## ADDENDUM NO. 4

Date: May 24, 2013  
To: Contractors  
From: Kurt Baxter – Region Director  
Reference: New Classroom Building  
UVU - Orem, Utah  
DFCM Project No. 12192790  
Subject: **Addendum No. 4**

ADDENDUM NO. 4  
May 23rd, 2013

Utah Valley University Classroom Building  
Orem, Utah

**C105**

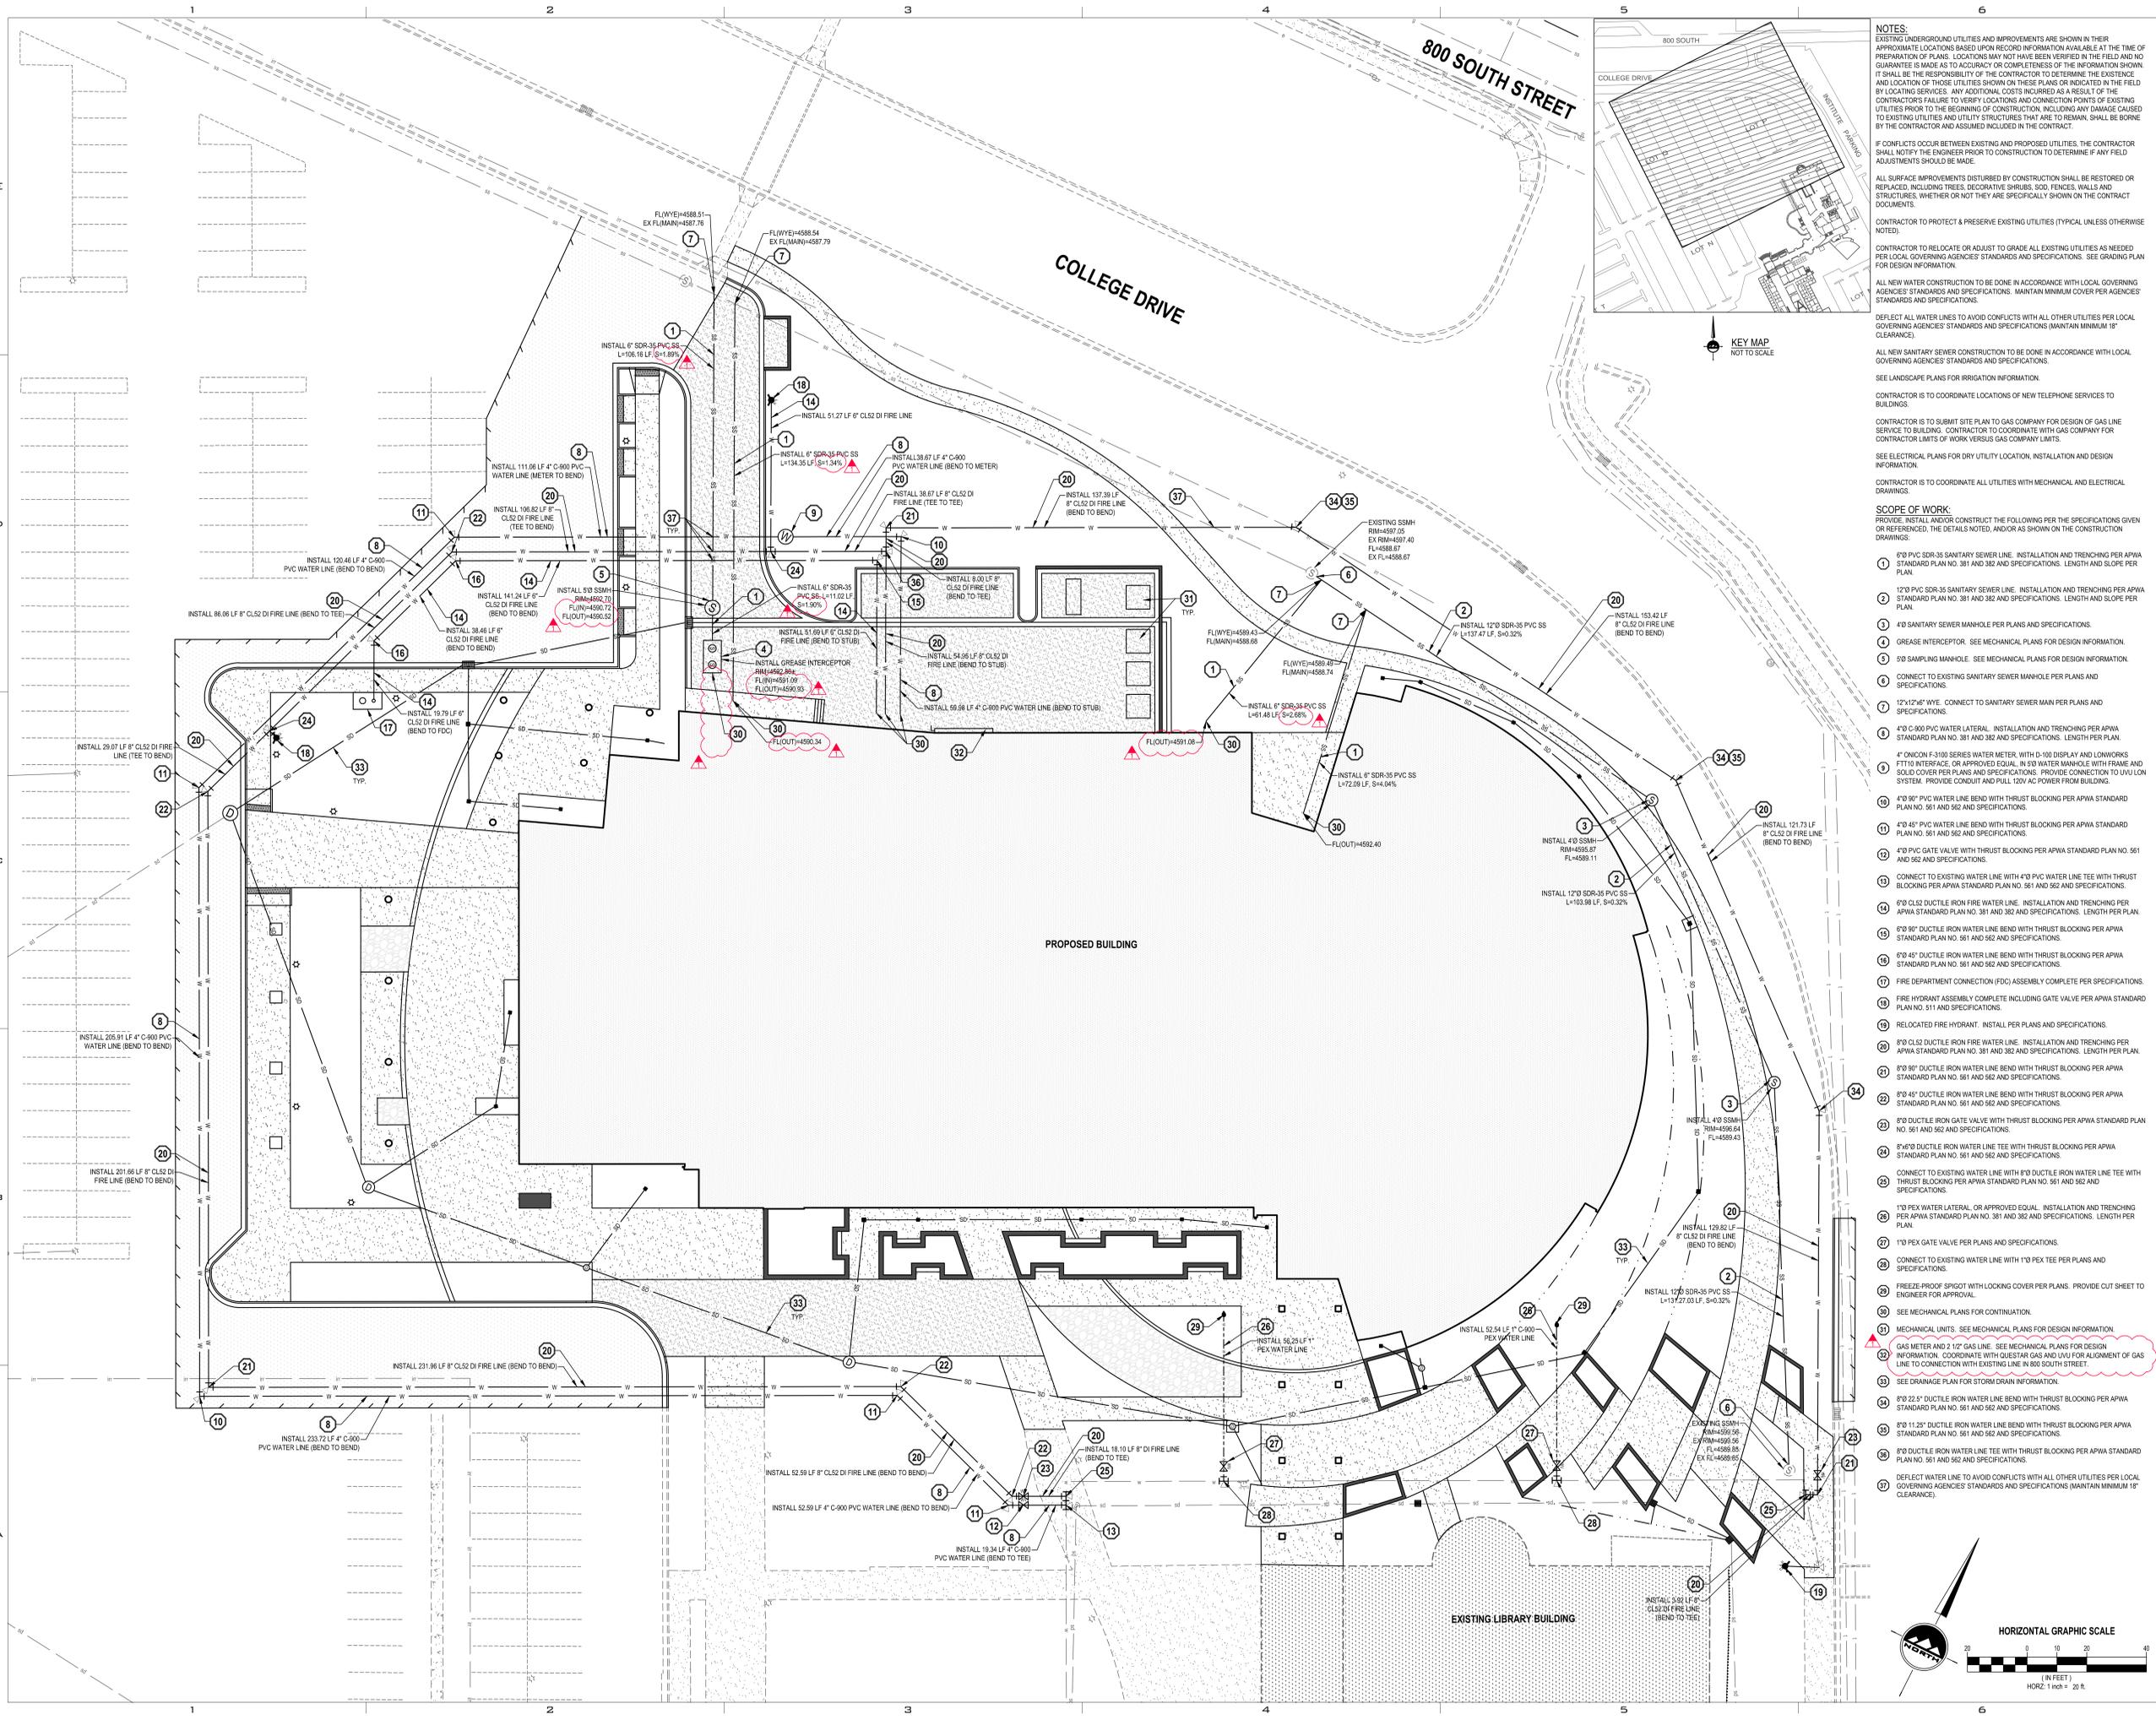
In spec 211000-1.4.A and Keyed Note #2 on FF101, there is explicit instruction that the site utilities contractor will terminate the fire water line inside the building. However, on drawing C105, the fire water lines stub and terminate at a point roughly 5' outside the building footprint. Please indicate on the Civil utilities plan that fire water lines should be stubbed into the building and should terminate with a blind flange 12" above finished floor elevation.	The site contractor shall comply with section 211000.
Please update the alternates section of 230500 (paragraph 1.10) to correspond to the Classroom Building project.	Will update in Addenda 5
Follow-up to question #23 above: specification 230529-3.10.D and -3.11.B.3 gives requirements for painting piping where exposed to view in concourses. Please indicate this as clearly as possible on the architectural finish schedule and in the Division 9 Painting specifications, as well.	There is no pipe exposed in the concourse.

Note 26 on C105 calls for "Pex" water lateral. Is this a correct designation or is this supposed to be poly pipe?	This pipe is for a hose bib connection. cross-linked polyethylene pipe is the preferred material.
Will ADS storm drain piping be acceptable in lieu of the A-2000 piping called for on sheet C104? In addition, since this project will be obtaining LEED certification, ADS piping is local whereas A-2000 is not.	N-12 ADS pipe may be used provided the contractor can provide hydraulic calculations which demonstrate the pipe diameters are unaffected. Currently several of the pipes have minimum cover and an increase in pipe diameter to achieve proper hydraulic capacity may not meet manufacturer's minimum cover requirements.
The Hedera helix groundcover is called out to be a 1 gallon (refer to sheet LS302). The symbol for this plant is a SF symbol not a count symbol, what is the install spacing of this plant?	12" o.c.

**CONDUIT DEVELOPMENT**

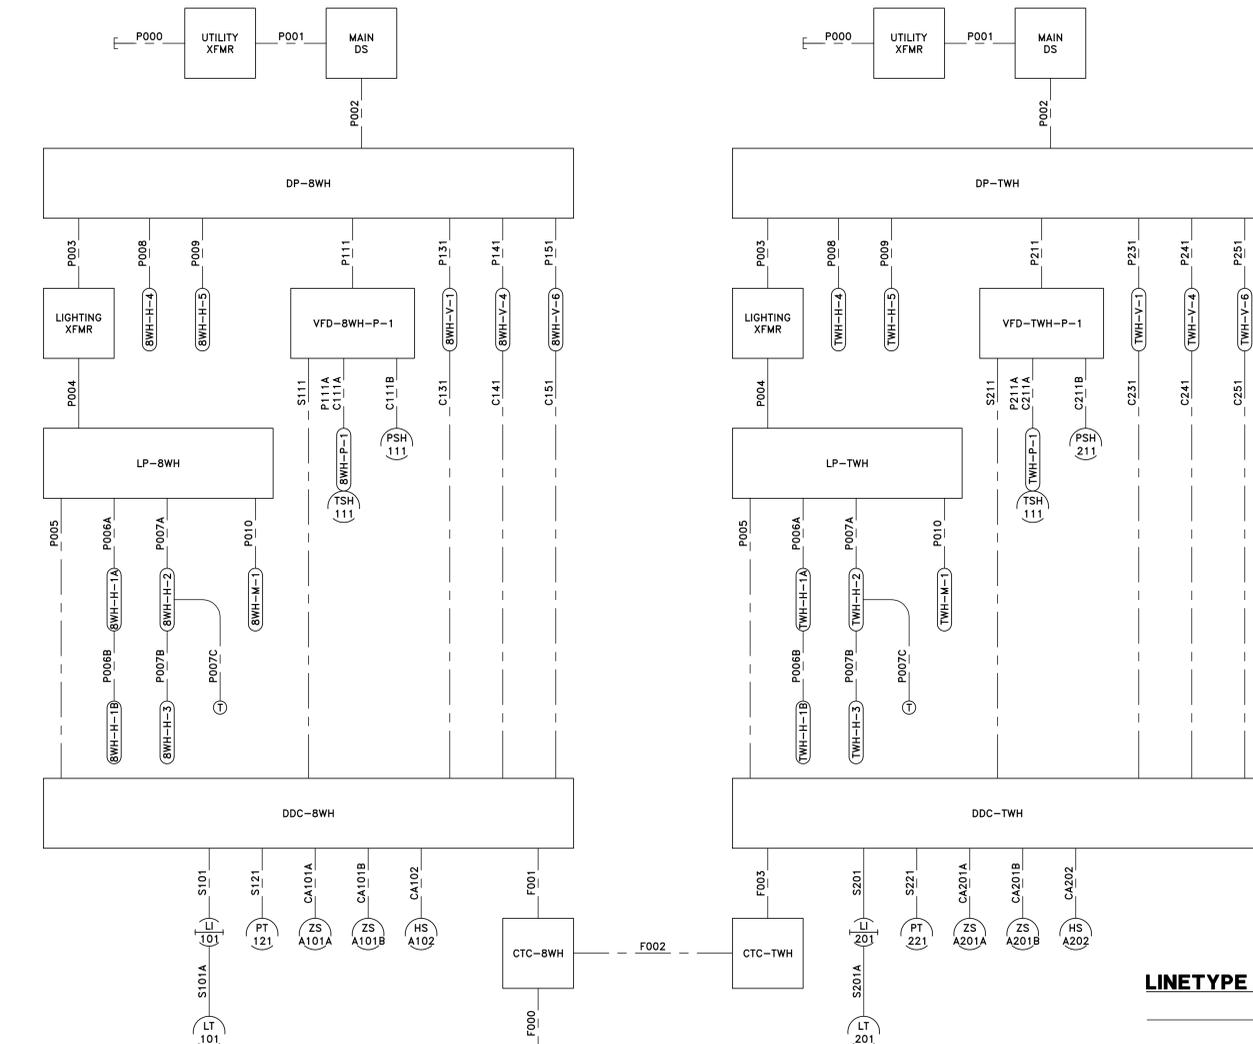
The ceramic tile finish legend and specification are conflicted on the size of tile. Please specify the size of tile to use.	The finish legend is correct.
Per drawing SF612 it shows stiff and drift clips with pins in tension. Is this the desired connection?	Will be clarified in addenda 5
The reinforcing has not been called out on the CRP-1 for the piers. Please clarify	Will be clarified in addenda 5
Please confirm a plastic or synthetic form liner is not an acceptable product for the architectural board formed concrete?	Correct.
The 300 kVA Transformers , note #2, are called "UVU transformer". On sheet EJ101 and EJ603 they are called "UTILITY XFMR". Who provides and installs these transformers?	Transformers are to be provided and installed by the contractor. Connection to primary power will be done by the owner's electrical utility.
In the Well TWH Conduit Schedule, conduit P001 Is called out as (2) parallel runs. Please verify this is correct. (See conduit P001 in Well 8WH Schedule).	Conduit runs P001 & P002 should be single runs only for both well houses. No parallel conduits are necessary. Refer to Sheet EJ603 – Rev.3 – May 22, 2013.
